RELEVANT INFORMATION FOR COUNCIL

FILE: D/2016/563 **DATE:** 21 November 2016
TO: Lord Mayor and Councillors
FROM: Graham Jahn, Director City Planning, Development and Transport
SUBJECT: Information Relevant To Item 9.9 – Development Application: 74-88
 Botany Road, Alexandria - At Council - 21 November 2016

74-88 BOTANY ROAD ALEXANDRIA

Figure 1: extract from floor plan showing the location of high level operable louvre windows within bathrooms for apartments at the rear of the site. See attachment A for greater detail.

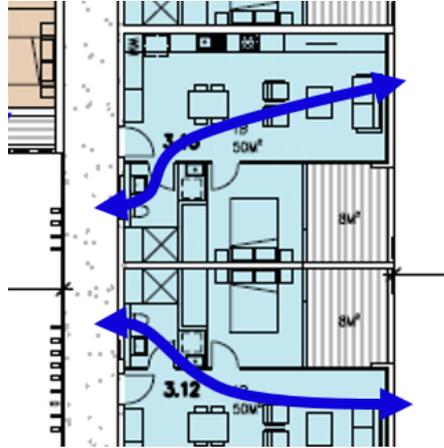
Council's assessing officer and urban design specialists met with the applicant in relation to this issue. Amended plans were subsequently submitted, demonstrating 55% of apartments are provided with natural cross ventilation. This has been achieved by providing all apartments located at the rear of the site with operable high-level air louvre windows within non-habitable areas (bathrooms). The louvre windows are of sufficient size to provide natural cross ventilation to the apartments and may be closed when desired, to provide acoustic privacy for the occupants of the dwellings (see Figures 1 and 2 below for details).

The applicant has also amended floor plans numbered DA04 to DA06 to correct a drafting error that did not show vents within all bathrooms for apartments at the rear of the site. As such, it is recommended that Condition (2)(c) be deleted, as the required vents are now shown on amended plans.

~~(c) vents are to be provided between non-habitable rooms and circulation areas for apartments numbered 1.02, 1.03, 2.02, 2.03, 3.02, 3.03, and 3.02 (Level 4), 3.03 (Level 4) to provide natural cross ventilation;~~

Figure 2: extract from submitted plan DA08 showing details for high level operable louvre windows that provide natural cross ventilation to apartments at the rear of the site via non-habitable rooms

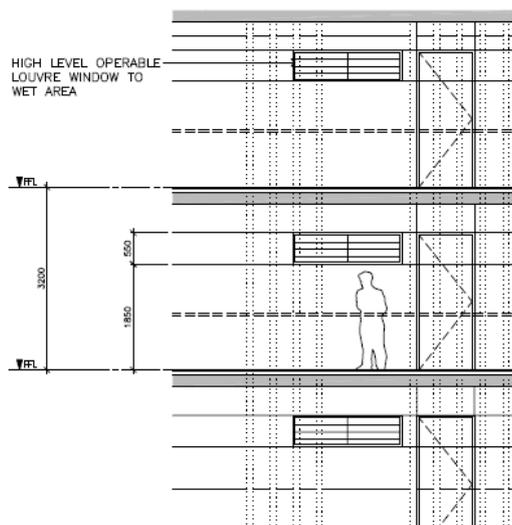
It is also to be noted that the applicant has provided a new plan numbered DA08 to better illustrate the operation of plenums that draw clean air from the internal parts of the site into the solar chimneys (see Figures 3 and 4 below and Attachment B). The solar chimneys achieve natural ventilation to apartments facing Botany Road when their doors and windows are closed.

Figure 5: extract from submitted plan DA04 showing 'offset' planting to maximise canopy spread

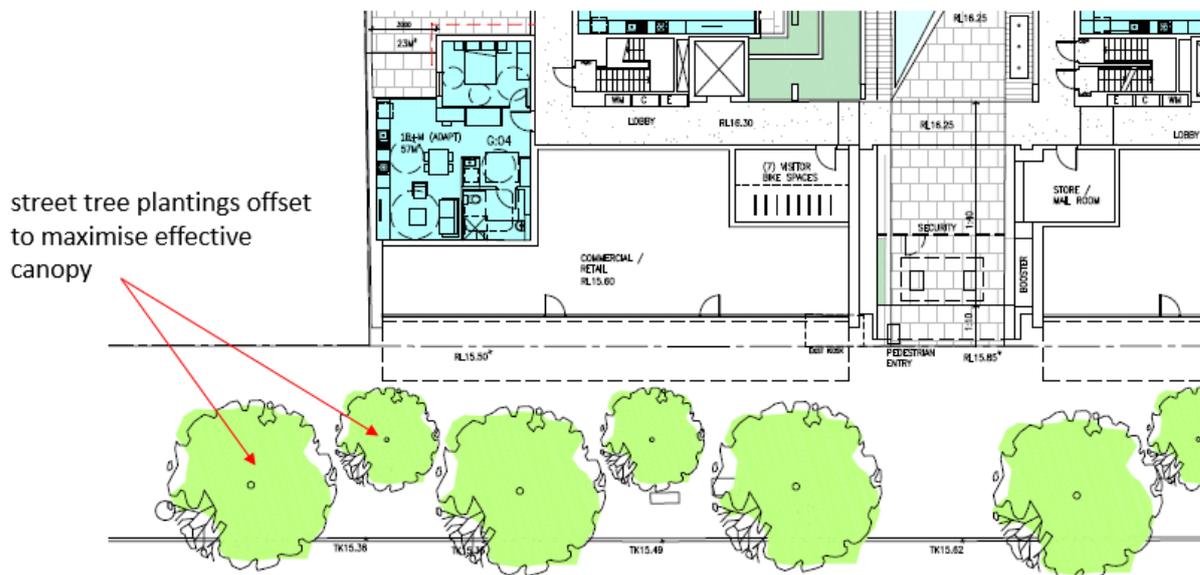
It is recommended that a new Condition numbered (11A) be included in the conditions of consent, requiring the provision of additional street trees at Botany Road. Condition (11A)(b)(i) is recommended to require street trees to be planted so that their trunks are 'offset'. This will maximise the width of their canopies once mature (see Figure 5 below).

It should be noted that Council's Tree Management Officer does not support the installation of a 'double row' of street trees along Botany Road. This is because the species identified for the site by the Street Tree Master Plan have wide canopies:

If planted in a double row, street trees would be forced to compete with one another, resulting in deformed canopies (hence the recommendation above for 'offset' street tree planting intended to maximise canopy spread).

(i) street trees being planted with their trunks 'offset' (as shown in plan number DA04), in order to maximise street tree canopy area at the Botany Road footpath;

ELEVATION A

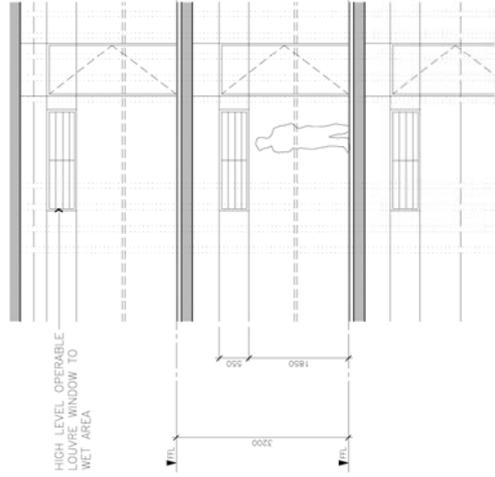
HIGH LEVEL OPERABLE LOUVRE WINDOW TO APARTMENTS:
 1-01, 1-02, 1-03, 1-12, 1-13, 1-14,
 2-02, 2-03, 2-12, 2-13, 2-14,
 3-02, 3-03, 3-12, 3-13, 3-14,
 4-02, 4-03

SECTION B

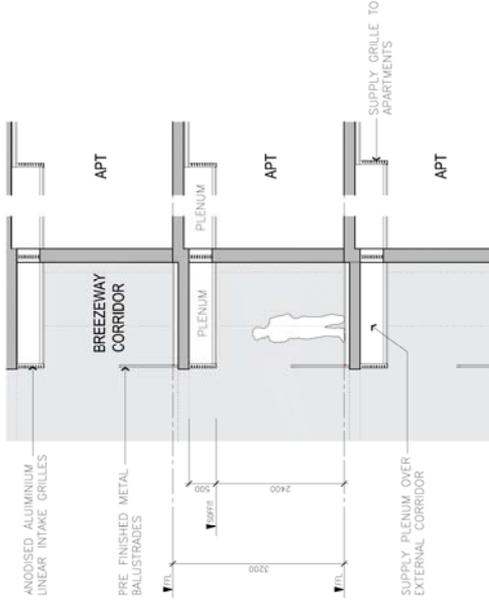
VENTILATION / SOLAR CHIMNEY TO APARTMENTS:
 1-09, 1-10, 1-11,
 2-04, 2-05, 2-06, 2-09, 2-10, 2-11,
 3-04, 3-05, 3-06, 3-09, 3-10, 3-11,
 4-04, 4-05, 4-06, 4-07
